LTB01149NAS2

# TECHNICAL BULLETIN

501-14: Handles, Locks, Latches and Entry Systems

'Hood open' Warning Message Displayed On Instrument Cluster

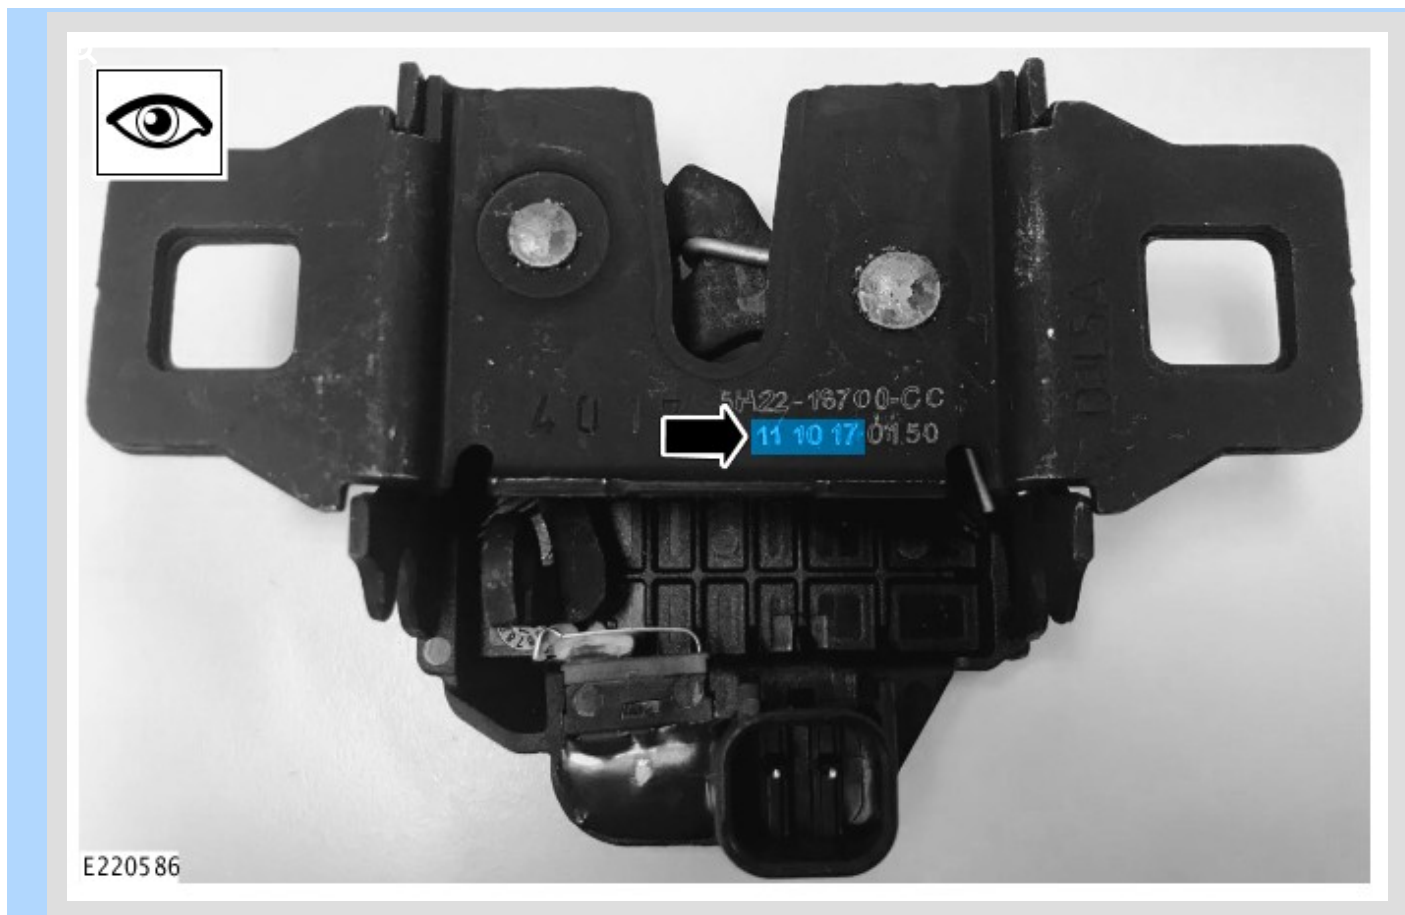
Date shown, **11 10 17** (11 October 2017), for reference only.

The date code (DD MM YY) of the new hood latch must be **27 04 18 (27 April 2018) or later.**
